APPLICATION NO.	FILING DATE	FIRST NAMED INVENTOR	ATTORNEY DOCKET NO.	CONFIRMATION NO.
10/629,116	07/28/2003	Peter Mardilovich	200309593-1	5931

Office Action Summary	Application No. 10/629,116	Applicant(s) MARDILOVICH ET AL.	
	Examiner CYNTHIA LEE	Art Unit 1795

Response to an Appeal Brief

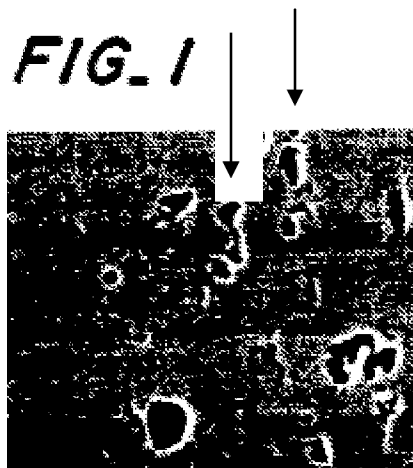
Regarding claim 55 and 57, Fig 1 and 2 depicts images of the porous substrate. Absent a definition of what the Applicant means by "substantially," the pores shown in Fig 2 and 3 meet the limitation "substantially uniform in size and shape."

Regarding claim 64, the pores are parallel. See fig. 1 below:
